# Access Compliance Report
Public Rights-of-Way
(Curb Ramps)

Intersection ID: 10037026   **Main Street:** S_TRYON_ST   **Cross Street:** N/A   **Location:** N

ADA ID: 4F99DFBA07B5   **Ramp Type:** PerpDiag   **Initial Pass/Fail:** Fail   **Overall Compliance:** No   **Severity Score:** 46.25

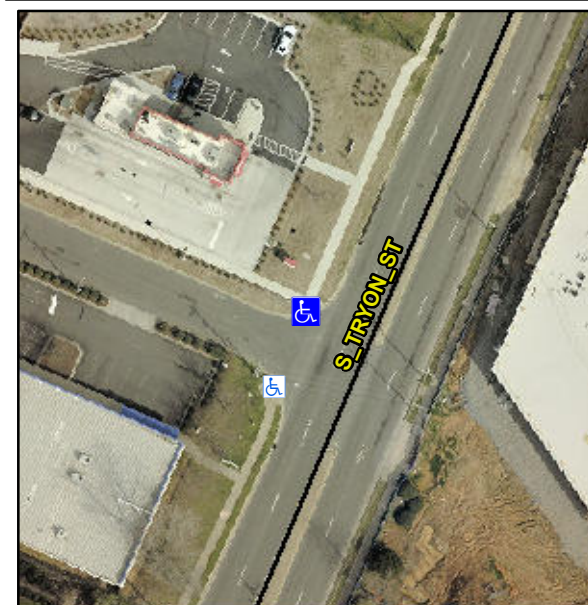
Not Found, R304.5.1, R304.2.2, R304.5.3

Compliance	Description	Data	Compliance	Description	Data
N/A	Ramp Length (in)	96.0	No	Ramp Slope (%)	11.0
No	Ramp Width (in)	36.0	No	Ramp XSlope (%)	7.3
N/A	Flare Type LT	N/A	N/A	Flare Type RT	N/A
N/A	Flare Slope LT (%)	N/A	N/A	Flare Slope RT (%)	N/A
N/A	Flare Traversable LT?	N/A	N/A	Flare Traversable RT?	N/A
N/A	Landing Length (in)	N/A	N/A	DWS Provided?	N/A
N/A	Landing Width (in)	N/A	N/A	DWS Contrast?	N/A
N/A	Landing Slope (%)	N/A	N/A	DWS Length (in)	N/A
N/A	Landing X Slope (%)	N/A	N/A	DWS Full Width?	N/A
N/A	Landing Curb? (Y/N)	N/A	N/A	DWS Offset (in)	N/A
N/A	Shared Landing?	N/A			
N/A	Gutter Ponding?	N/A	N/A	Gutter Slope (%)	N/A
N/A	Gutter Lip Ht (in)	N/A	N/A	Gutter X Slope (%)	N/A
N/A	Painted X Walk1?	No	N/A	Painted X Walk2?	No
	X Walk 1 Direction	To SE		X Walk 2 Direction	To SW
N/A	X Walk 1 Width (in)	N/A	N/A	X Walk 2 Width (in)	N/A
	X Walk 1 Slope (%)	8.6		X Walk 2 Slope (%)	2.0
	X Walk 1 X Slope (%)	0.2		X Walk 2 X Slope (%)	6.1

Remove & Replace Curb Ramp With Two New Directional Ramps or Equivalent.
